Access Compliance Report

Public Rights-of-Way

(Curb Ramps)

Intersection ID: 26345	Main Street: BEAUCATCHER_LN	Cross Street: RHETT_BUTLER_PL	Location: SE
ADA ID: BD87E397AADE	Ramp Type: BlendTrans1	Initial Pass/Fail: Fail	Overall Compliance: No
Severity Score: 35			
Codes/Mitigation Info/Possible Solution		Field Measurements/Component Compliance

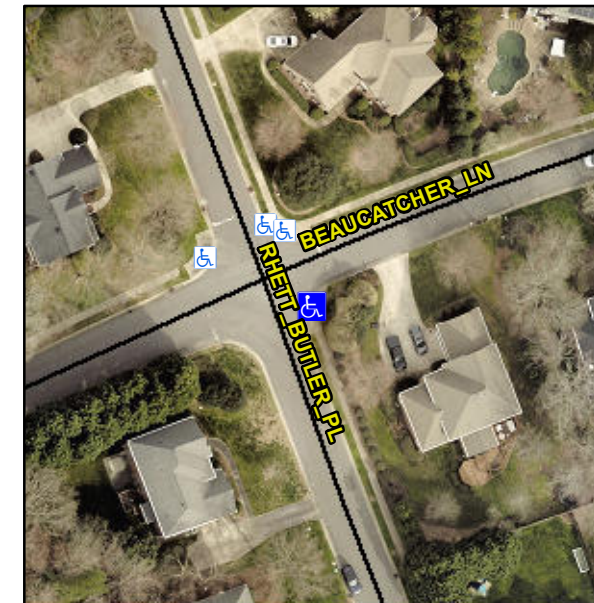
DWS MISPLACED

Not Found, R304.5.1

Compliance	Description	Data	Compliance	Description	Data
N/A	Ramp Length (in)	96.0	Yes	BlendTrans Slope (%)	2.1
No	Ramp Width (in)	28.0	Yes	BlendTrans XSlope (%)	1.3
N/A	Flare Type LT	N/A	N/A	Flare Type RT	N/A
N/A	Flare Slope LT (%)	N/A	N/A	Flare Slope RT (%)	N/A
N/A	Flare Traversable LT?	N/A	N/A	Flare Traversable RT?	N/A
N/A	Landing Length (in)	N/A	N/A	DWS Provided?	N/A
N/A	Landing Width (in)	N/A	N/A	DWS Contrast?	N/A
N/A	Landing Slope (%)	N/A	N/A	DWS Length (in)	N/A
N/A	Landing X Slope (%)	N/A	N/A	DWS Full Width?	N/A
N/A	Landing Curb? (Y/N)	N/A	N/A	DWS Offset (in)	N/A
N/A	Shared Landing?	N/A			
N/A	Gutter Ponding?	N/A	N/A	Gutter Slope (%)	N/A
N/A	Gutter Lip Ht (in)	N/A	N/A	Gutter X Slope (%)	N/A
N/A	Painted X Walk1?	No	N/A	Painted X Walk2?	N/A
	X Walk 1 Direction	To NW		X Walk 2 Direction	N/A
	X Walk 1 Width (in)	N/A		X Walk 2 Width (in)	N/A
	X Walk 1 Slope (%)	4.2		X Walk 2 Slope (%)	N/A
	X Walk 1 X Slope (%)	3.3		X Walk 2 X Slope (%)	N/A

N/A	Ramp inside XWalk1?	N/A	N/A	Ramp inside XWalk2?	N/A
	Road Slope (%)	3.3		Clear Space?	N/A
	Road X Slope (%)	4.2	N/A	Clear Space to XWalk (in)	N/A
N/A	Any Obstructions?	N/A	N/A	Storm Grate/Utility Hazard?	N/A
	Obstruction Type			Storm Grate/Utility Type	
		N/A			N/A
			Yes	Surface Condition? (G/P)	Good
			No	Curb Slope (%)	10.3

Remove & Replace Curb Ramp With Two New Directional Ramps or Equivalent.
